DOCKETED	
Docket Number:	21-DR-01
Project Title:	Supply Side Demand Response
TN #:	241492
Document Title:	San Diego Gas & Electric Company Comments - Attachment to SDG&E Comments on SSDR Working Group Draft Report
Description:	N/A
Filer:	System
Organization:	San Diego Gas & Electric Company
Submitter Role:	Public
Submission Date:	2/8/2022 4:51:18 PM
Docketed Date:	2/8/2022

Attachment to SDG&E Comments on SSDR Working Group Draft Report

Qualifying Capacity of Supply-Side Demand Response Working Group Draft Report

January 2022 | CEC-200-2022-001-CMD

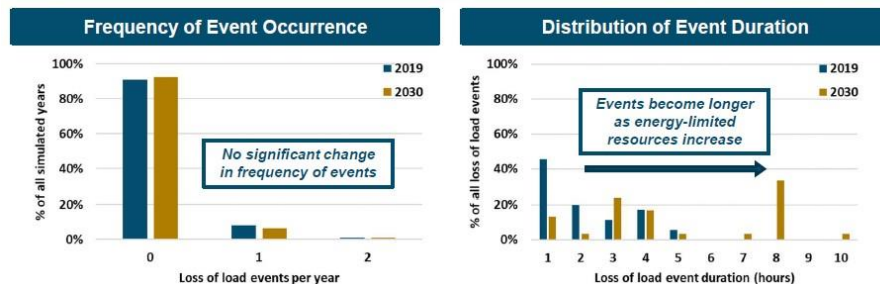
The table below compares the results of using a simple average to the use of LOLE as a weighted average for Southern California’s Base Interruptible Program²⁸ and its commercial Summer Discount Plan (SDP) for A/C cycling. Because BIP customers have a relatively flat load shape and the program is available for all six hours of the LOLE, the results of the simple average of HE17-21 and weighted average of HW17-22 (highlighted in yellow) are the same. Note, the load impact results for BIP were adjusted to show a 6-hour call.

The SDP has a load reduction that is the highest in the first hour and then declines as commercial load falls off due to customer fatigue and/or commercial business hours. In this case, the hourly load impacts make different contributions toward reliability across time. The use of hourly LOLE as weights will be a better measurement of the value of load reduction over the reliability event. In this case, the qualifying capacity is 19 MW instead of 20 MW. However, since SDP is available for a 6-hour call, in this example a positive value should exist for HE22, so the weighted average should be slightly higher.

HE	SCE-BIP		SCE-SDP-Commerical	
	Load Impact		Load Impact	
	LOLE	MW	MW	
16	0.0%	0	0	
17	1.4%	494	28.95	
18	25.2%	498	23.72	
19	42.1%	494	18.78	
20	22.5%	495	14.90	
21	7.5%	497	12.61	
22	1.4%	506	-2.81	
23	0.0%	164	-1.21	
	100.0%			
	LIP Avg of HE17-21	LIP weighted by LOLE HE17-22	LIP-Avg HE17-21	LIP weighted by LOLE HE17-21
	496	496	19.79	18.58
SCE ExAnte LIP for PY2020 with 2021				
Impacts for September call, 1 in 2 weather year				
BIP HE22 adjusted to show full load reduction for 6 hour event				
NOTE: Since SDP can be called for 6 hours, hourly values needs revision.
